UNITED STATES PATENT AND TRADEMARK OFFICE

APPLICATION NO.	FILING DATE	FIRST NAMED INVENTOR	ATTORNEY DOCKET NO.	CONFIRMATION NO.
10/779,471	02/13/2004	Bradford G. Baruh	033151-026	5526
21839 7590 09/24/2007 BUCHANAN, INGERSOLL & ROONEY PC POST OFFICE BOX 1404 ALEXANDRIA, VA 22313-1404			EXAMINER DUNWOODY, AARON M	
			ART UNIT 3679	PAPER NUMBER
			NOTIFICATION DATE 09/24/2007	DELIVERY MODE ELECTRONIC

Office Action Summary	Application No.	Applicant(s)	
	10/779,471	BARUH, BRADFORD G.	
	Examiner	Art Unit	
	Aaron M. Dunwoody	3679

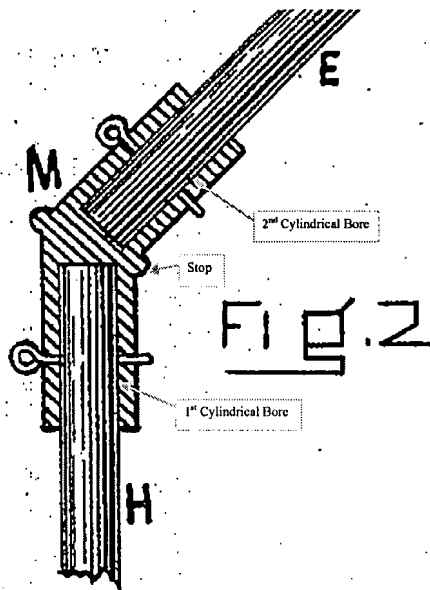
In regards to claims 1 and 23, Byrnes discloses a pipe coupling comprising:
an elongated housing (114) comprising a first end and a second end, the housing defining an elongated bore therein;

a stop (130) located on an inner diameter of the housing, the stop located between the first end and the second ends of the housing, wherein a distance from the stop to one of the first and second ends is at least two times a distance from the stop to the other of the first and second end of the housing;

a first bore extending from the first end to the stop; and

a second bore extending from the second end to the stop, wherein an angle between the first bore and the second bore is about 15 degrees to about 165 degrees, and wherein each of the bores are configured to allow a pipe end to advance into the pipe coupling until reaching the stop.
